SUBJECT: DuPage Airport  
West Chicago, Illinois  
DuPage County  
Illinois Project Number: DPA-4300  
SBG Project Number: 3-17-SBGP-XX  
Contract No. DU081  
Item No. 05A, 6-10-2016 Letting  
Addendum A

## NOTICE TO PROSPECTIVE BIDDERS

05A  
6-10-2016 LETTING

## CONSTRUCT WEST END PERIMETER ROADWAY

project	88849	contract	DPA-4300
drawing	CU-103	rev.	
sheet	of	sheets	
file

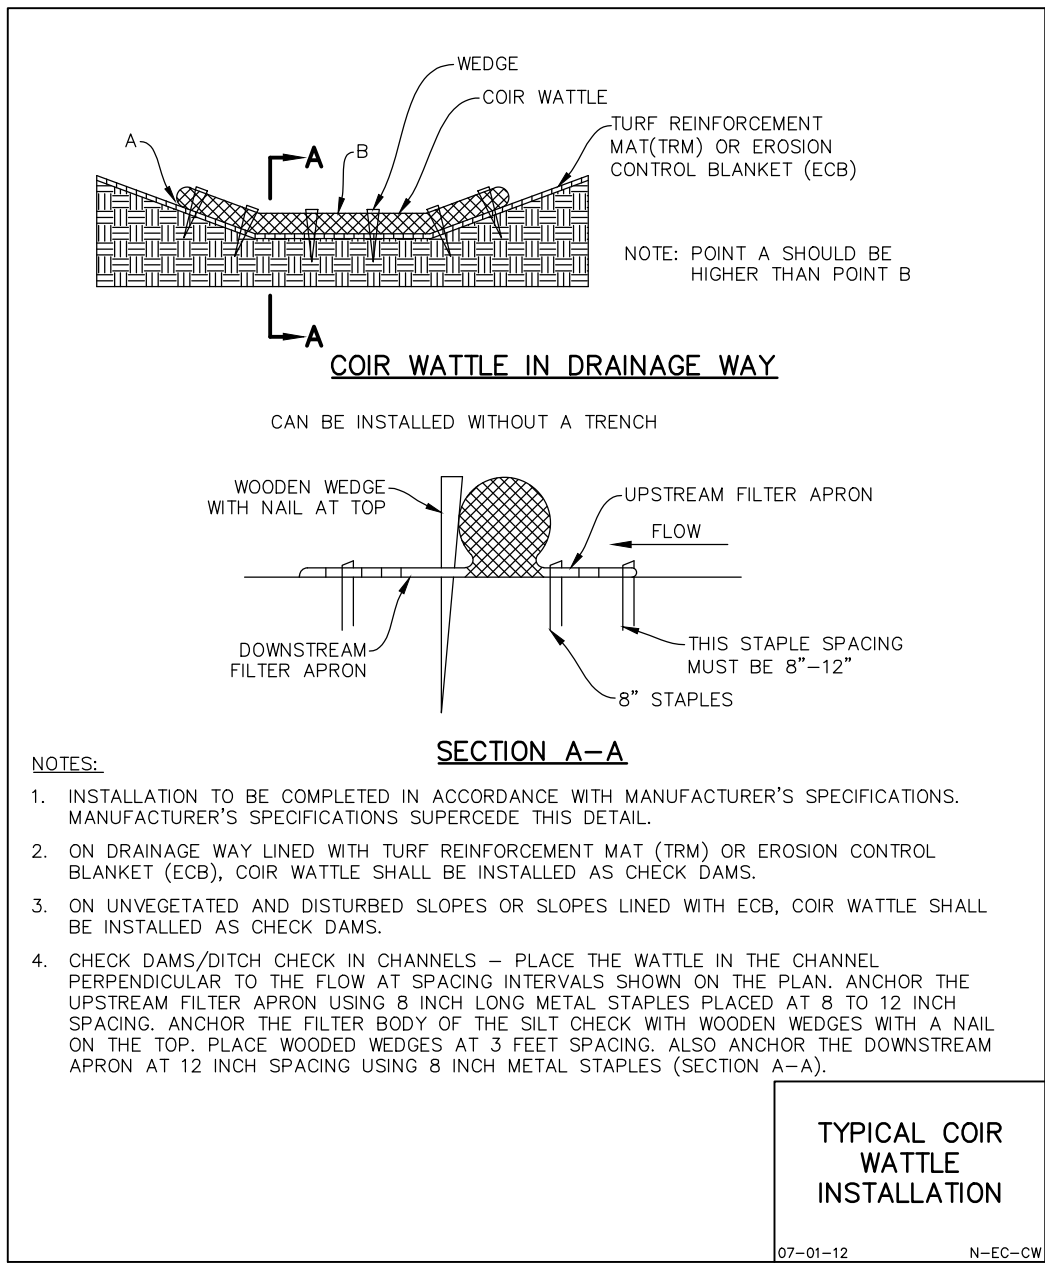
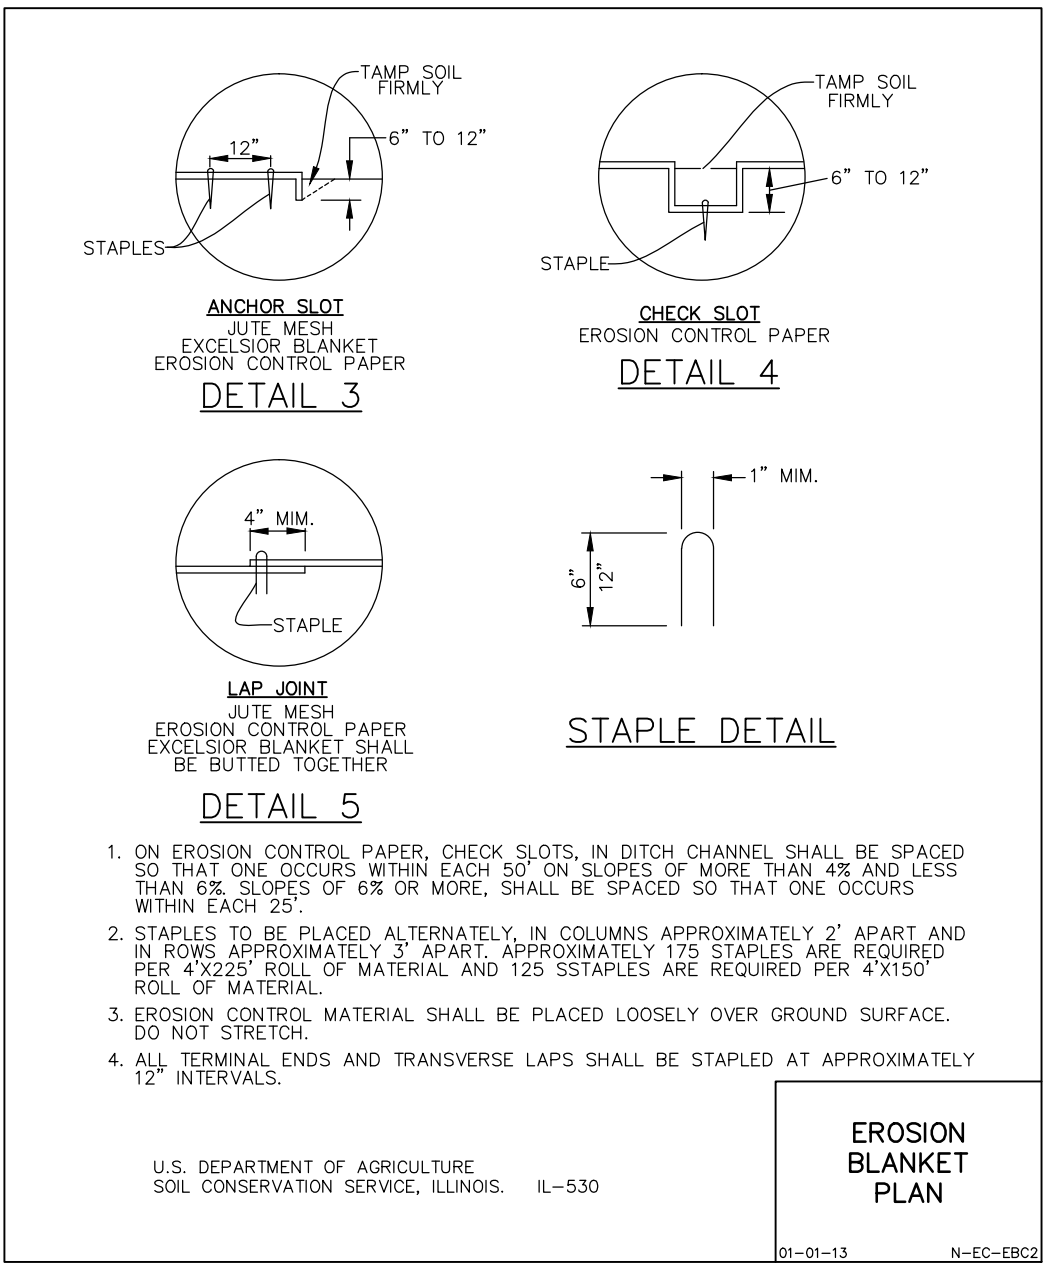
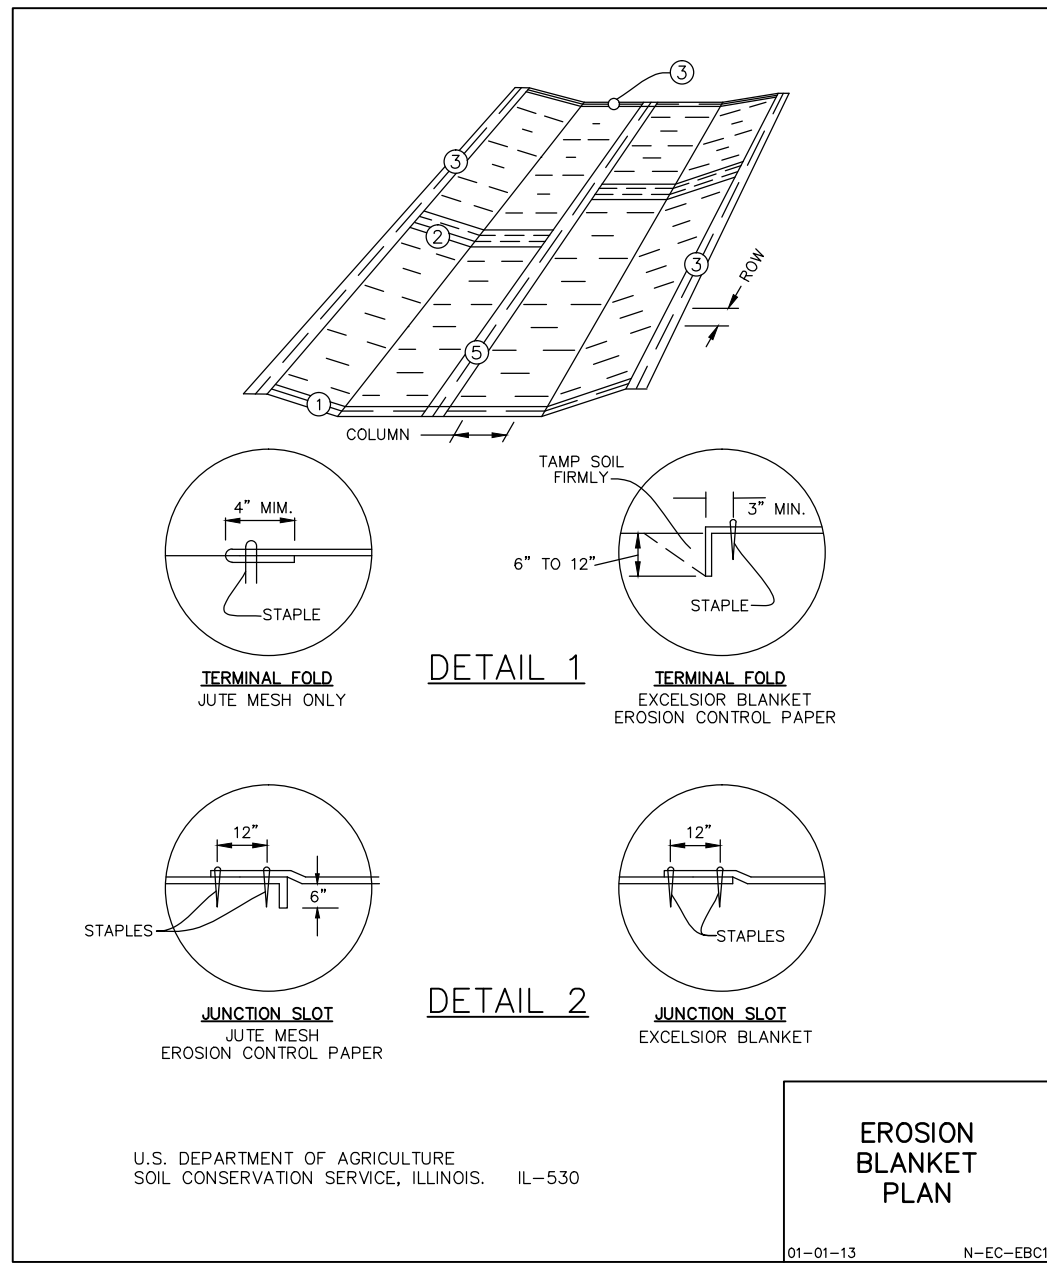
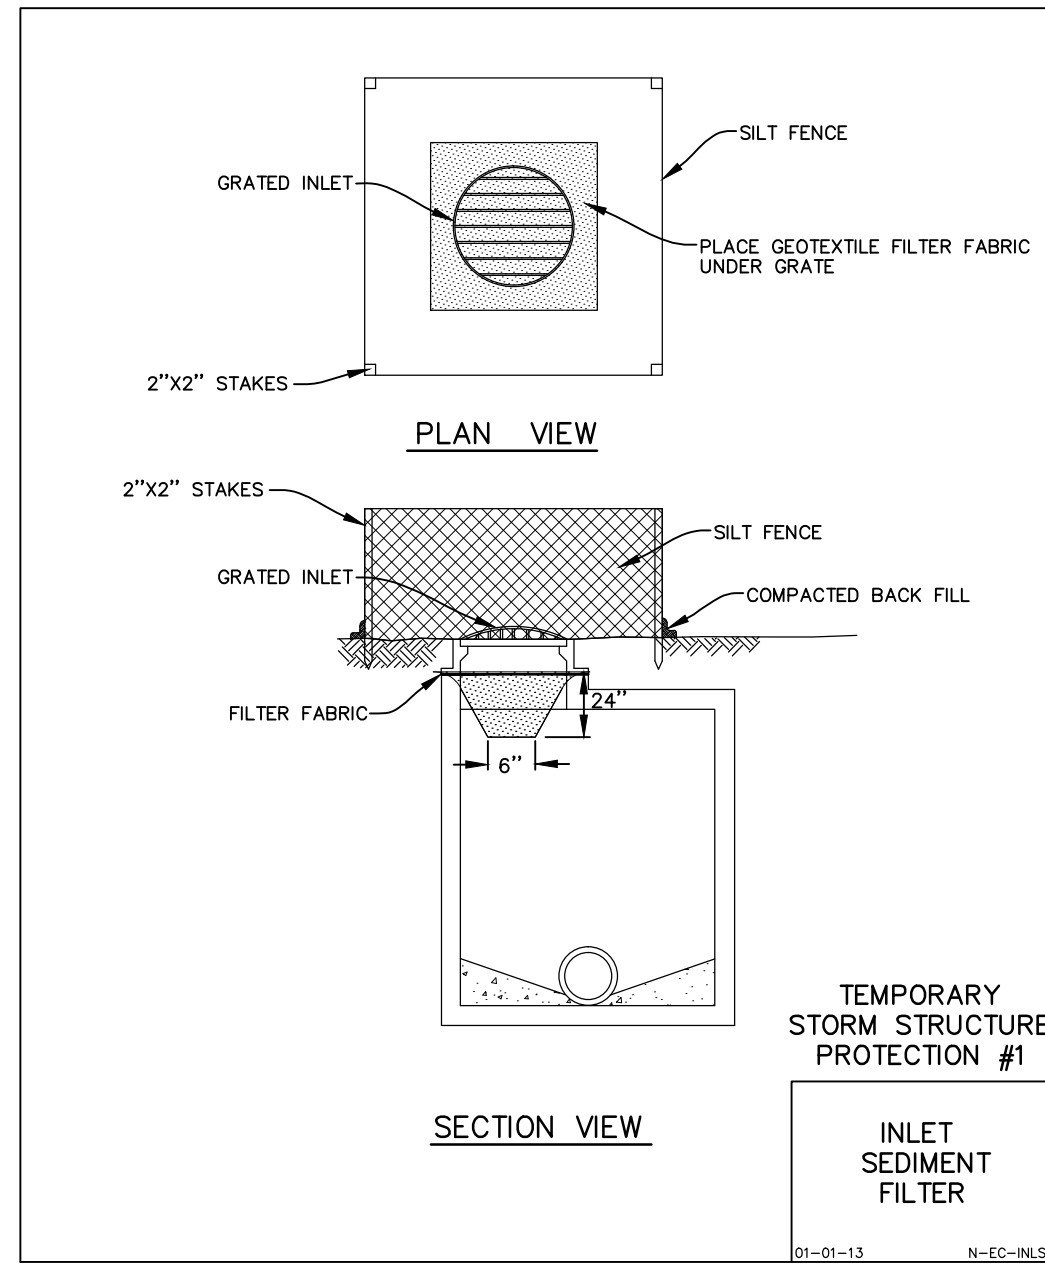
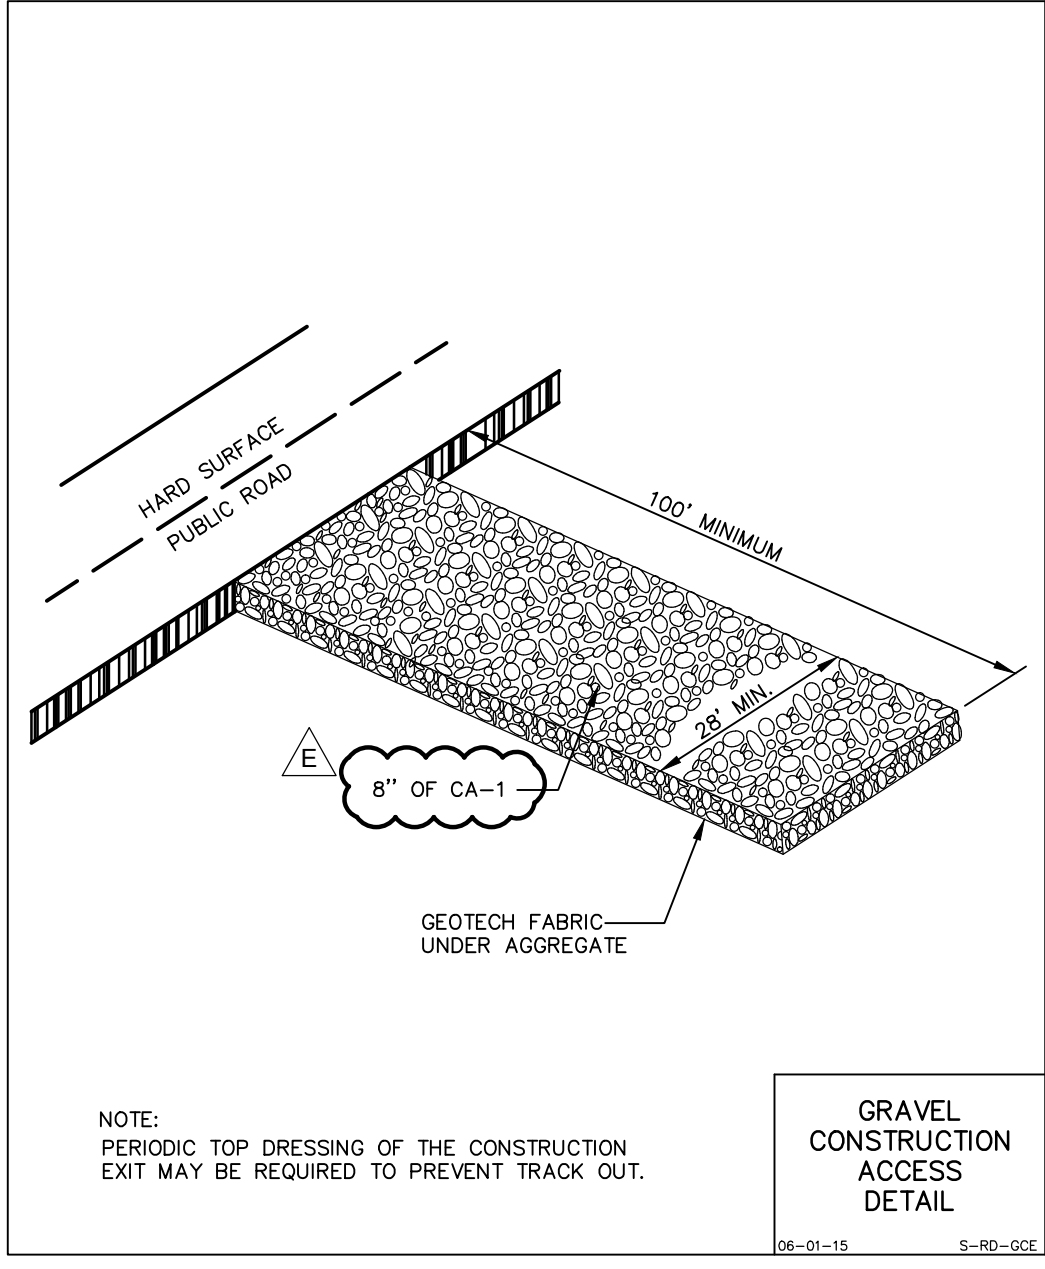
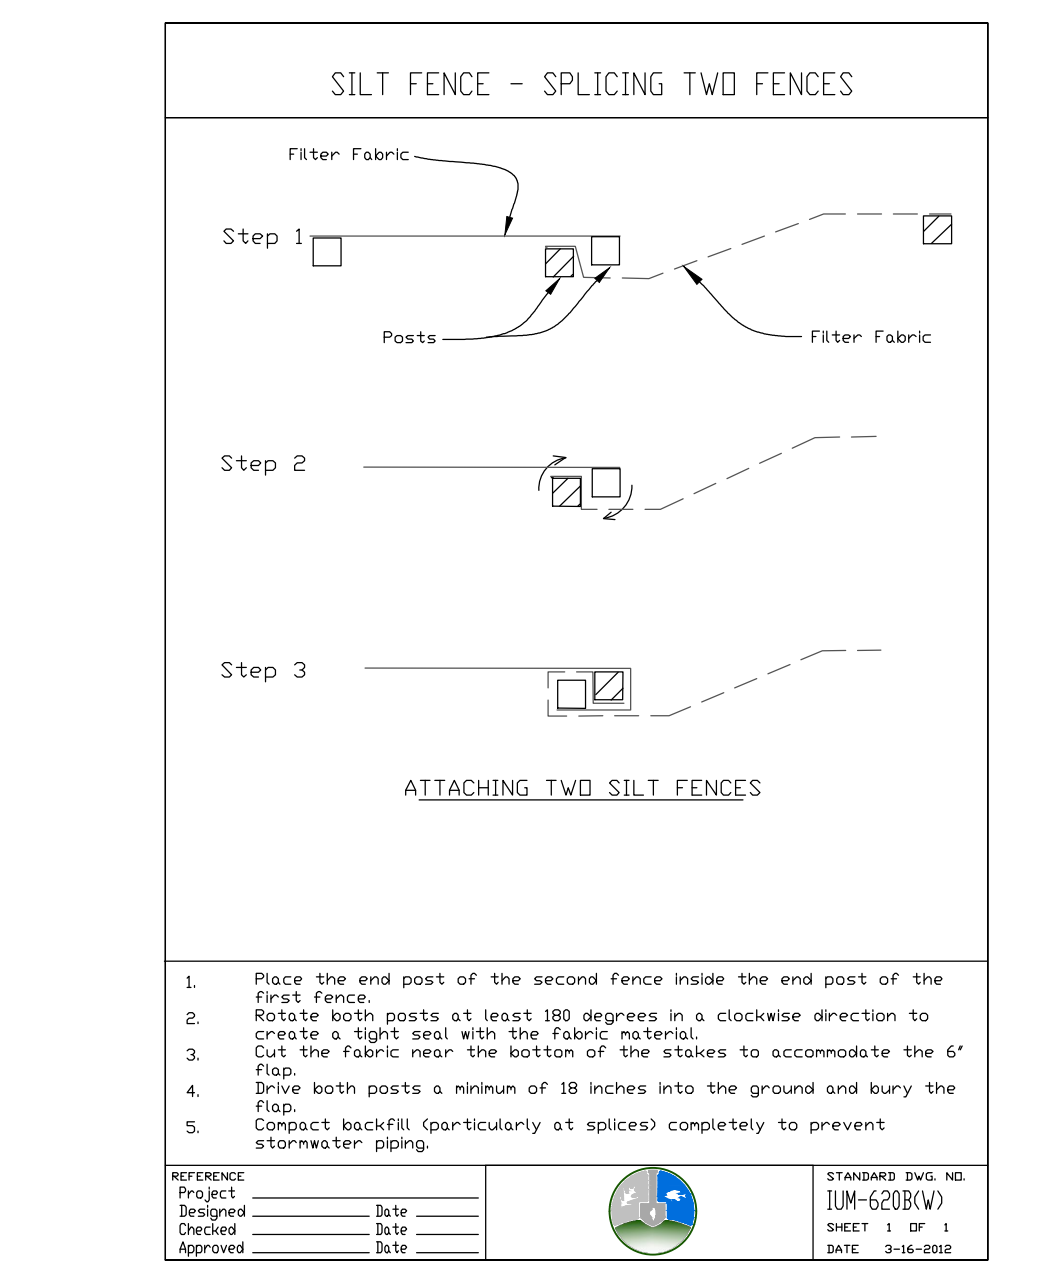
14. CG-102 and CG-103
  - Addition of soil borings and topsoil thickness.
15. CU-101, CU-102 and CU-103
  - Additional storm sewer structures shown and removed seed mix specifications and CU-202 has additional Gravel Construction Access Detail information

project	88849	contract	DPA-4300
drawing	CU-202	rev.

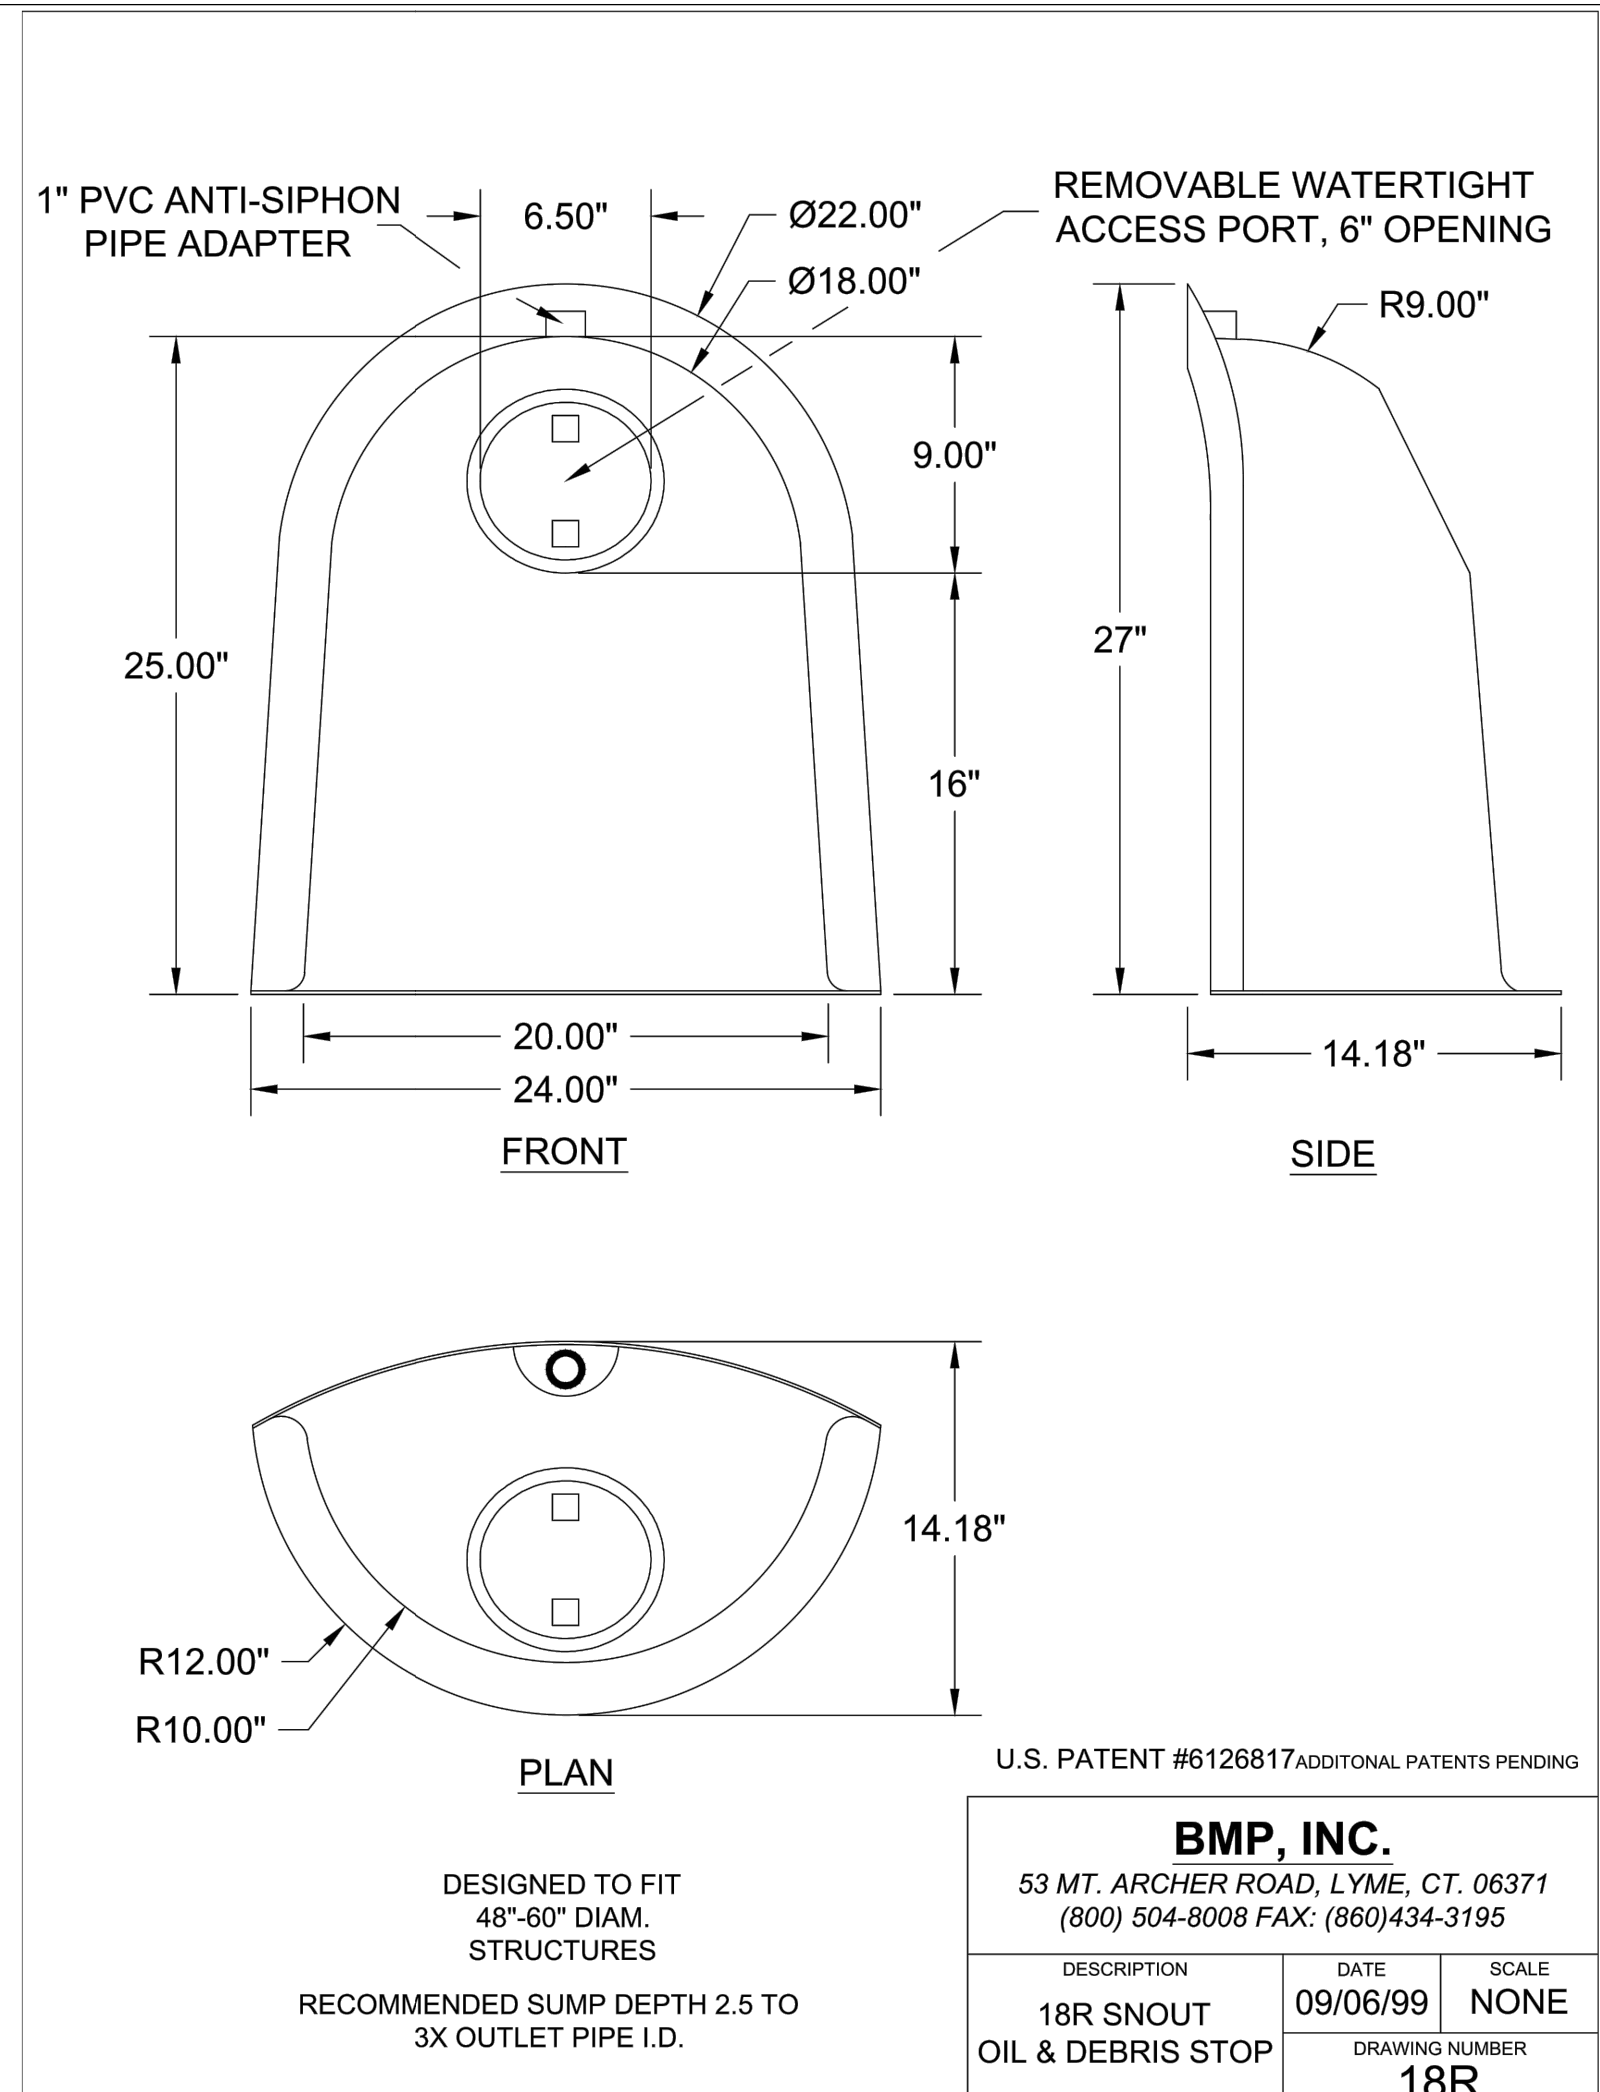
16. CU-202 and CU-204
  - Revision of storm sewer details
17. X-101, X-102, X-103, X-104, and X-105
  - Addition of cut and fill areas and volumes to plan sheets
